TECHNICAL BULLETIN

NO. 214-78-18

SUBJECT: REINFORCEMENT/REPAIR OF TAIL BOOM
P/N 214-030-003-7

HELICOPTERS AFFECTED: All Model 214B/R1 helicopters

FIGURE 6B

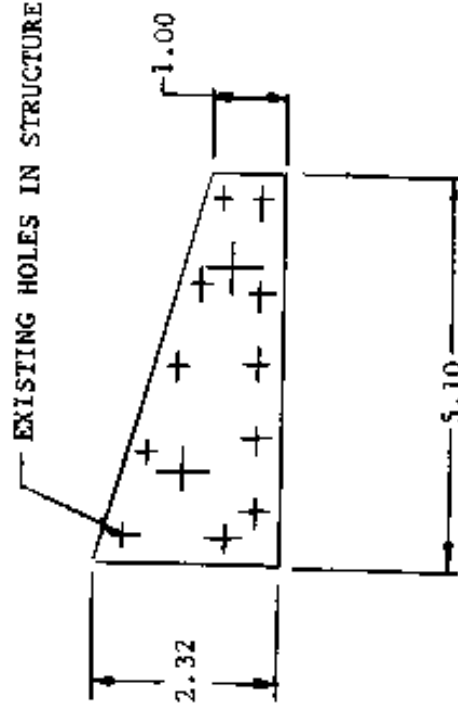
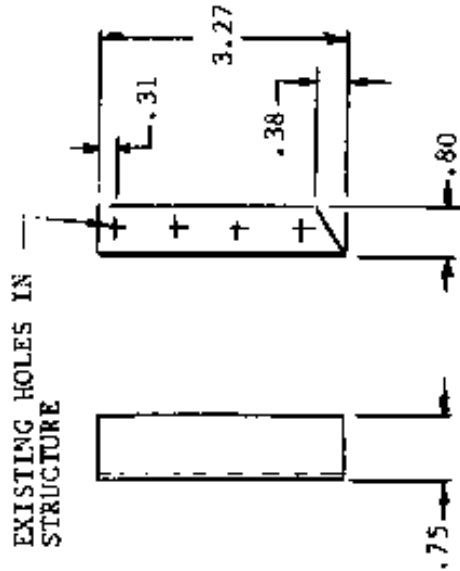
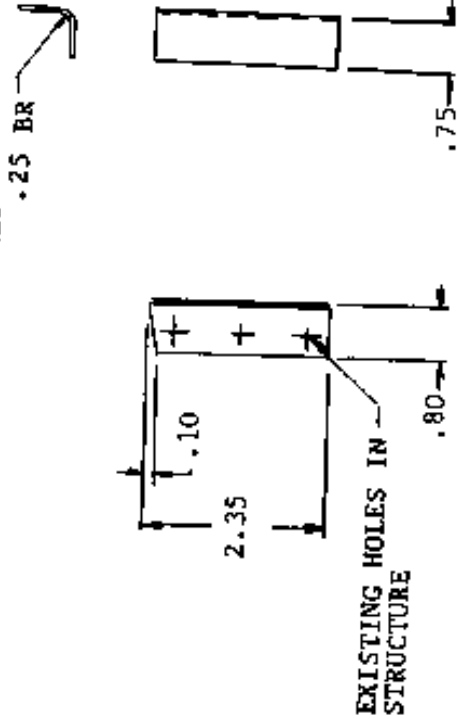
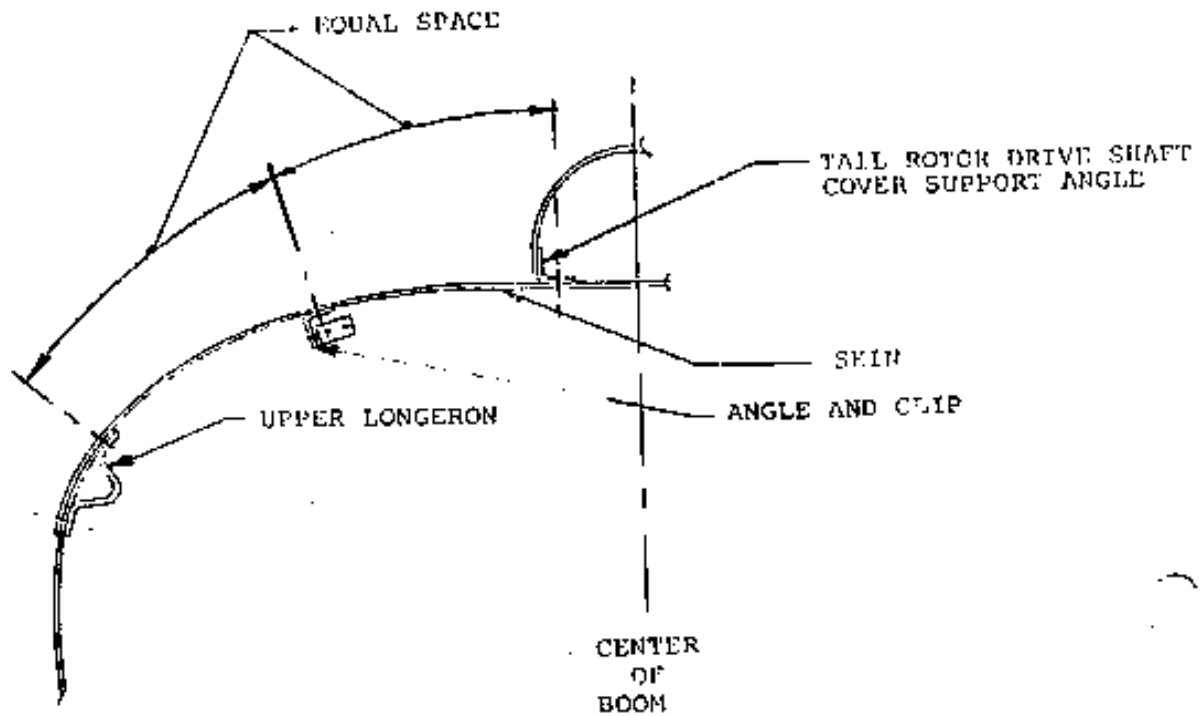
7. Refer to figure 5. Install new guide brackets.
8. Refer to figure 6B. Fabricate doublers "W" and "Y" and clips "X" and "Z". Alodine and prime with epoxy primer.

ANGLE DETAIL AND INSTALLATION
FIGURE 7

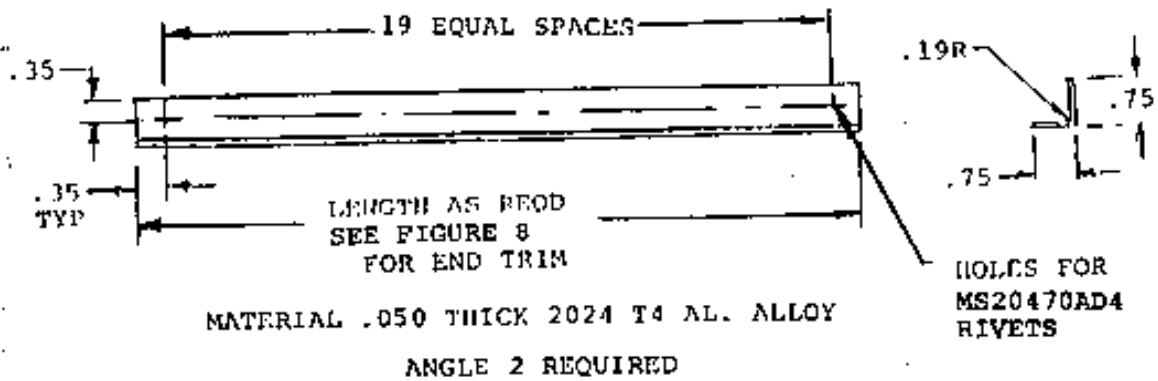
12. Refer to figures 7 and 8. Fabricate two angles and four clips. Locate the angles and clips. Drill all holes in the skin and bulkhead from the angles and clips. Remove angles and clips, de-burr all holes. Reinstall angles and clip with rivets as called out. Coat angles and clips with epoxy primer. Reinstall all removed panels.
